UNITED STATES PATENT AND TRADEMARK OFFICE

APPLICATION NO.	FILING DATE	FIRST NAMED INVENTOR	ATTORNEY DOCKET NO.	CONFIRMATION NO.
09/936,231	09/12/2001	Claude Dreulle Maurice	EDV/MAE BET 01/0599	2580
466	7590	12/17/2004	EXAMINER	
YOUNG & THOMPSON 745 SOUTH 23RD STREET 2ND FLOOR ARLINGTON, VA 22202			CHANNEY, CAROL DIANE	
			ART UNIT	PAPER NUMBER
			1745

Office Action Summary

Claim Rejections - 35 USC § 102

U.S. Patent Apr. 4, 1995 Sheet 3 of 8 5,403,679

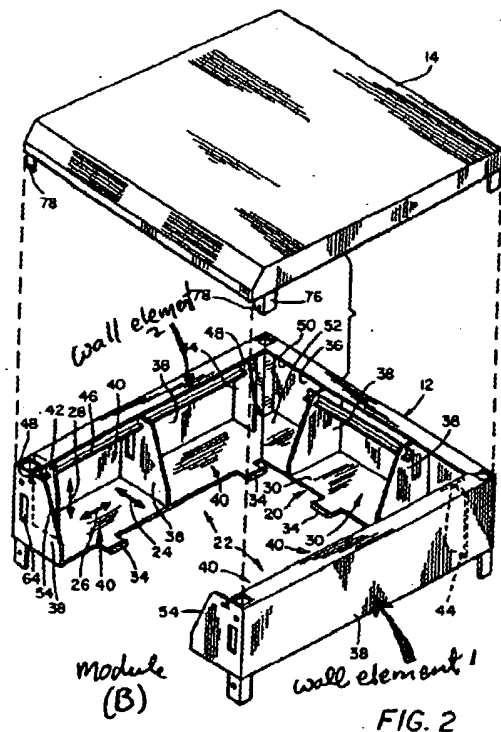
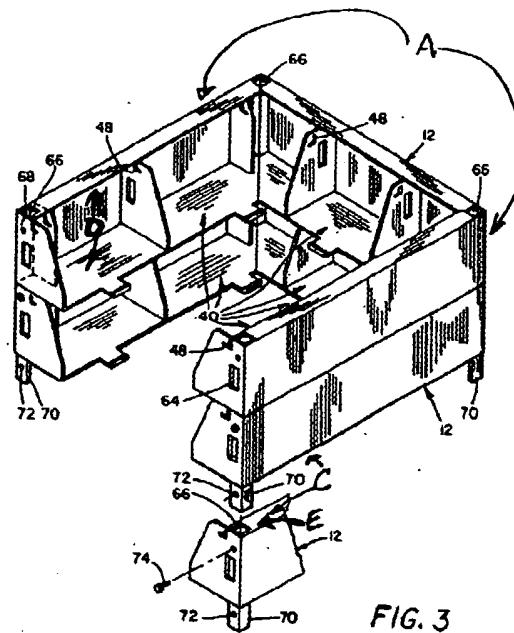
As shown in Figs. 2 and 3, the side walls (12) consist of an assembly of stacked modules (40), each having a pair of wall elements (38). These wall elements are mounted opposite each other. With regards to claim 10, each wall element has a folded edge, which combined with the bottom piece of the module above, forms a support for a row of batteries. With regards to claim 11, the battery includes retention means, (46) and (34). With regards to claim 12, posts (70) are removable rods, extending through the folded edges of the battery box.

With regards to claim 20, Stone discloses a battery box with two side walls (20) and two end covers (16). See Figure 1. The box further comprises:

(A) Two side wall which comprise an assembly of elementary interchangeable stacked modules.

(B) Each module comprises a pair of opposing wall elements.

(C) Each lower wall element supports an adjacent upper wall element.

(D) Each wall element is a U-section with arms pointing inwards toward and parallel with arms of an opposite wall element. Note that the "arms" are not of equal size, but are limited in that manner.

(E)The upper arm of each lower wall element serving as a support for a lower arm of the corresponding adjacent upper wall element.

With regards to the limitation "opposing lower arms of opposing wall elements providing opposing support bases for opposing parallel edges of any battery supported there between", Stone does not show batteries supported between two wall elements. Thus, this conditional limitation is met.
